SAFETY EVALUATION  
FOR THE  
VIRGIL C. SUMMER NUCLEAR STATION  
TRANSITION TO WESTINGHOUSE 17x17 VANTAGE 5 FUEL

SOUTH CAROLINA ELECTRIC & GAS COMPANY  
VIRGIL C. SUMMER NUCLEAR STATION  
DOCKET NO. 50-395

MAY, 1988

FIGURE 3.2-2  
K(Z)·NORMALIZED  $F_0(Z)$  AS A FUNCTION OF CORE HEIGHT

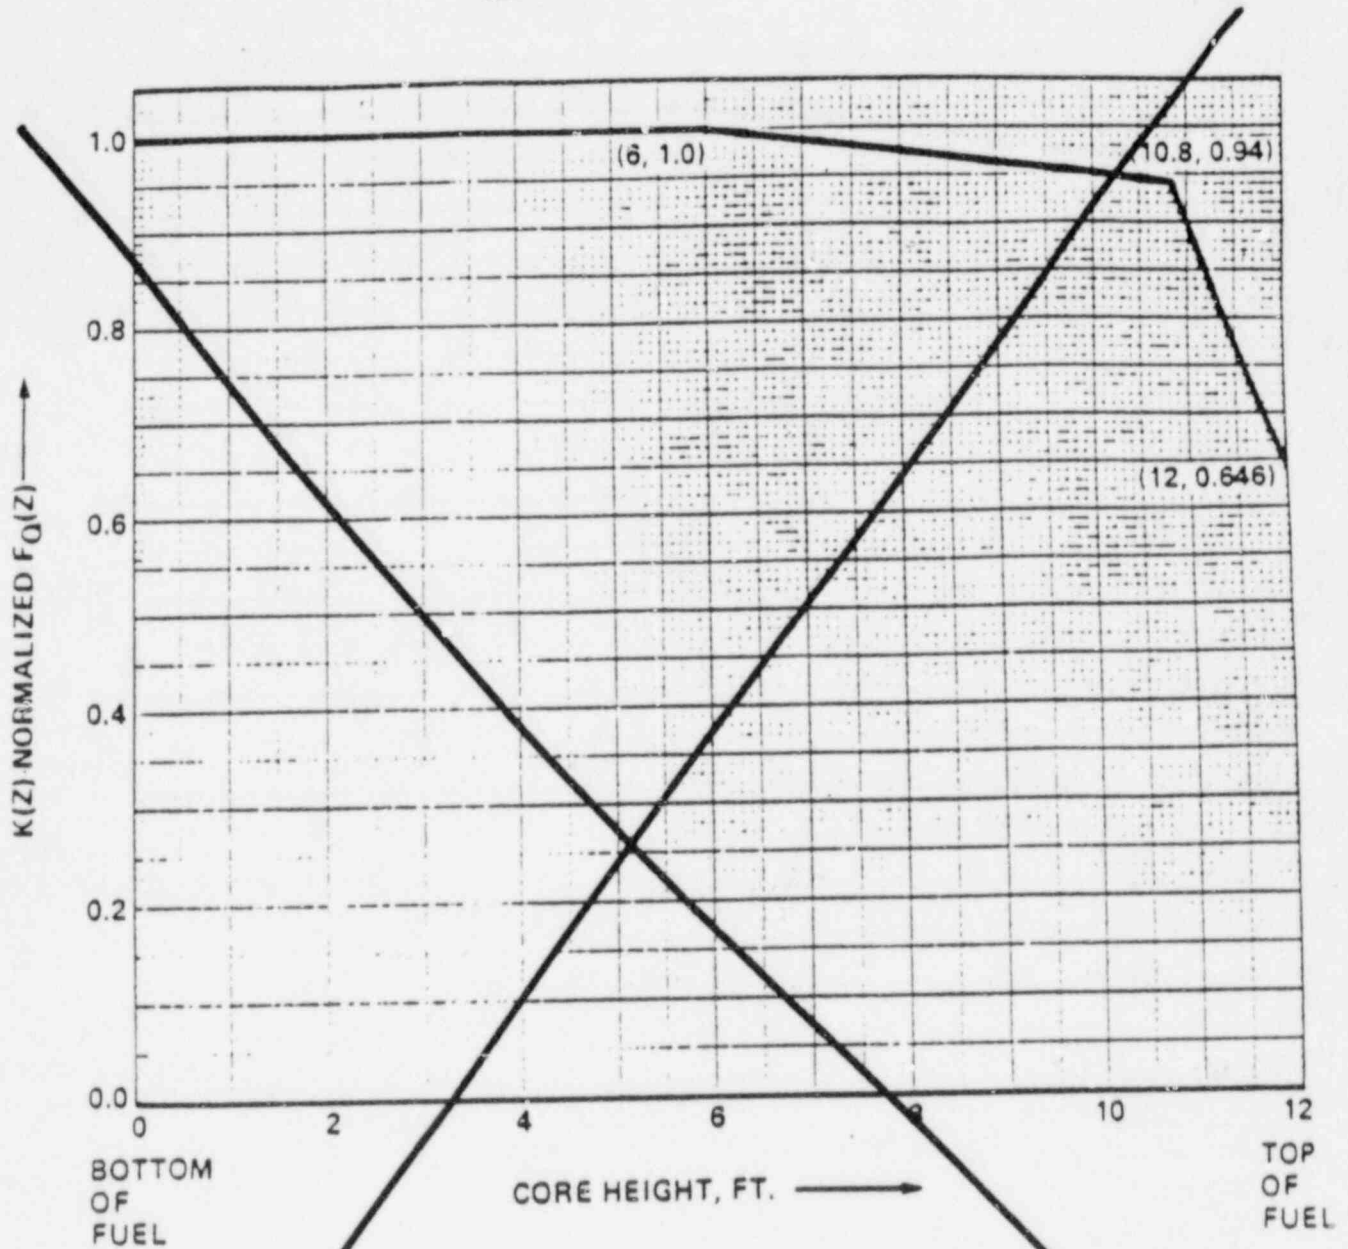
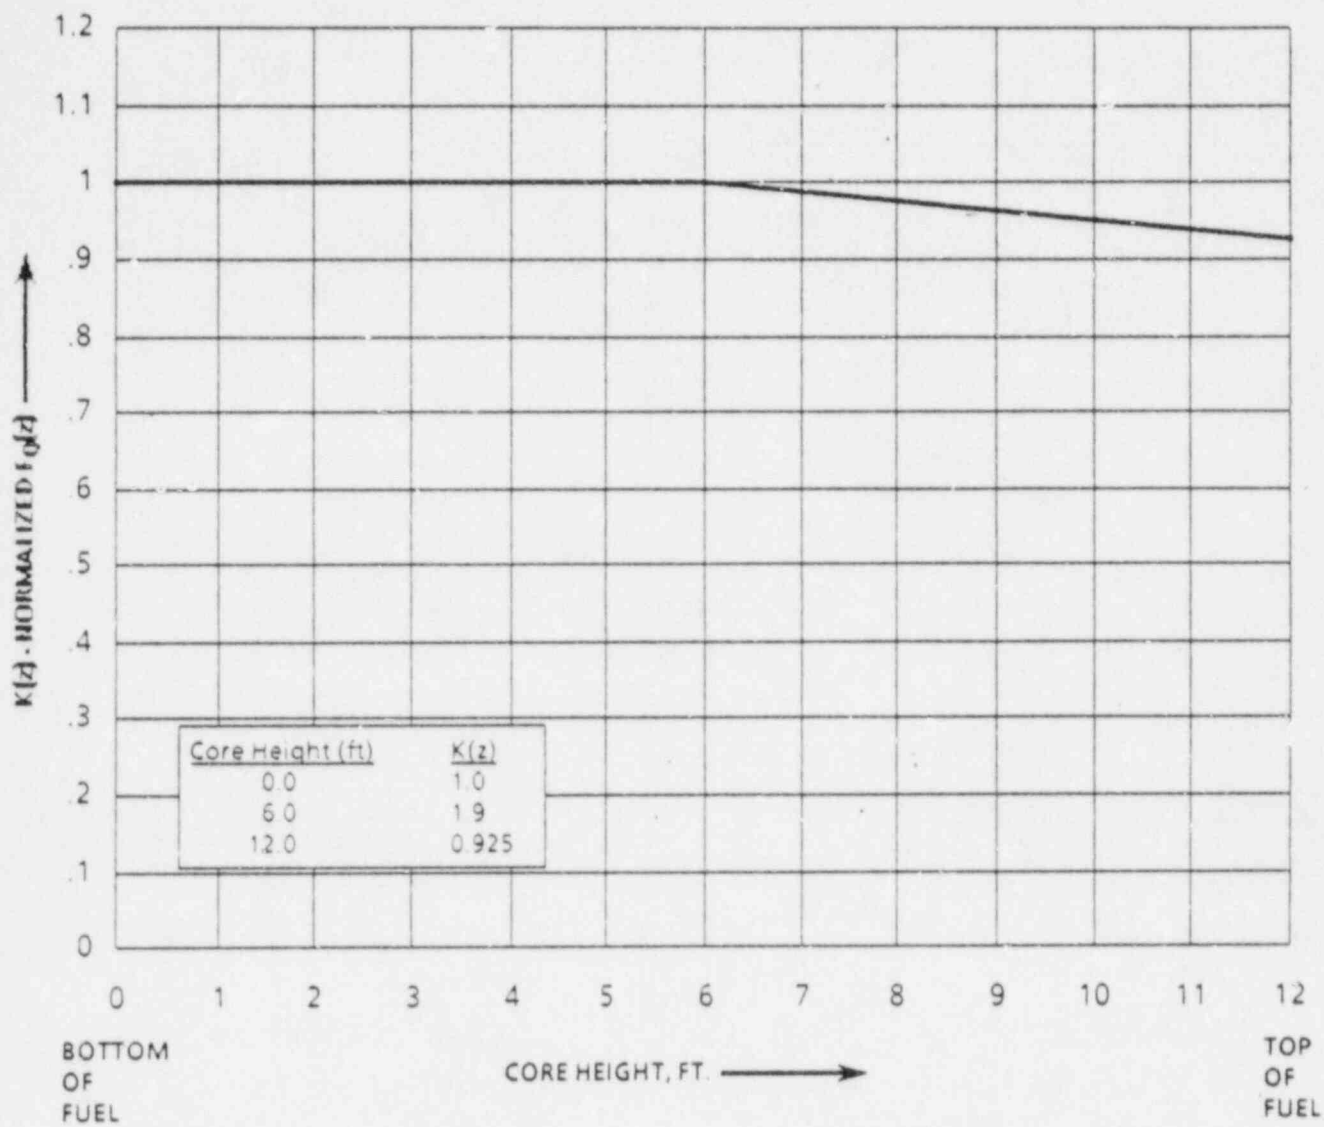
DELETE

REPLACE WITH NEW  
FIGURE 3.2-1

FIGURE 3.2-3 RCS TOTAL FLOW RATE VS. R THREE LOOP OPERATION

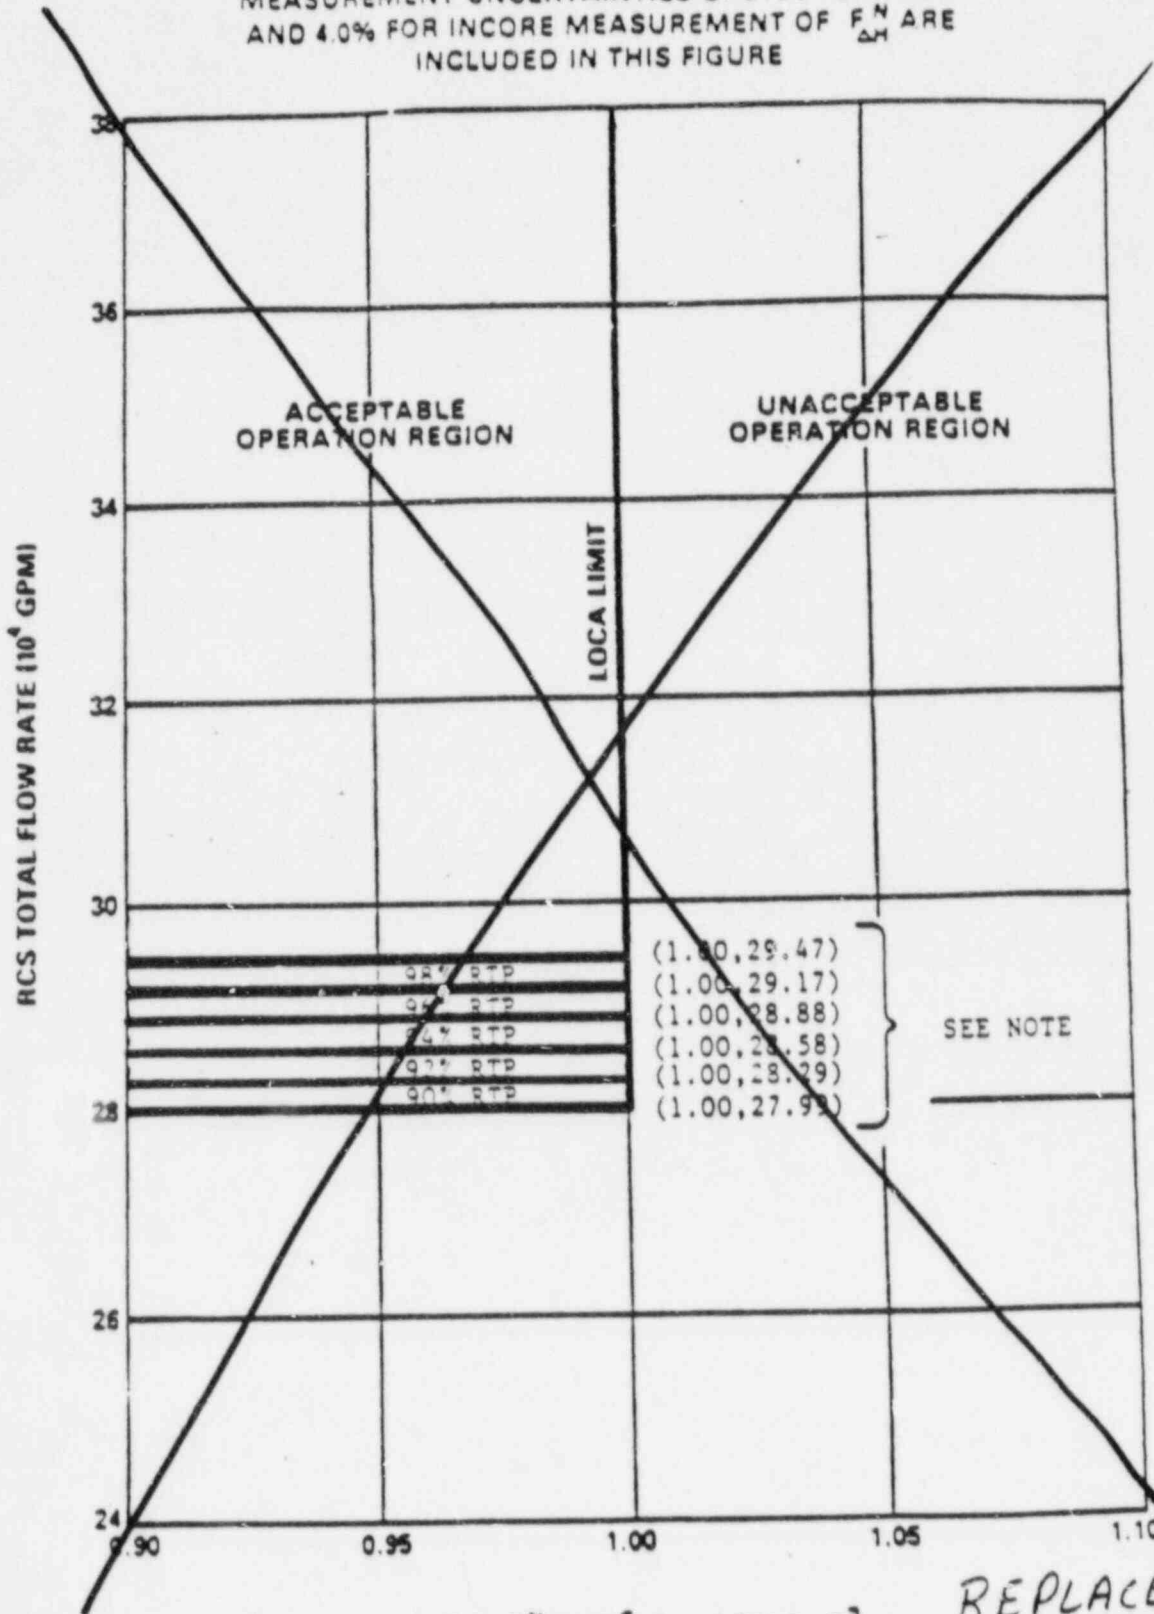
DELETE

REPLACE WITH  
New Fig. 3-2-2  
on  
OPPOSITE  
PAGE.

FIGURE B 3/4 2-1  
INDICATED AXIAL FLUX DIFFERENCE  
VERSUS THERMAL POWER

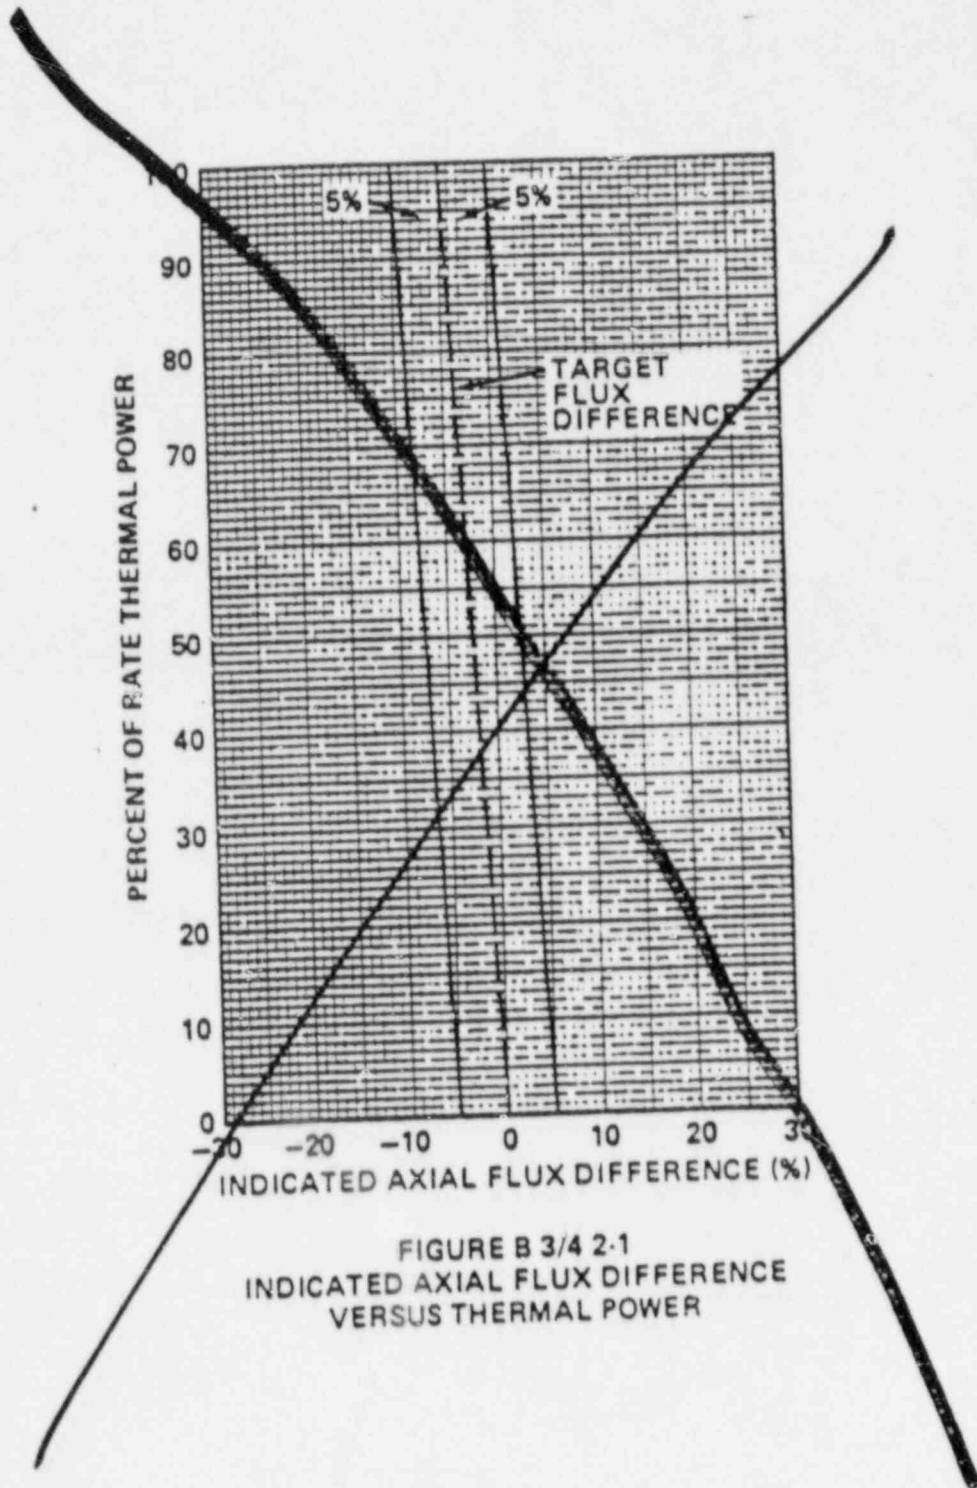
(This change deletes  
this Figure From Tech Specs)
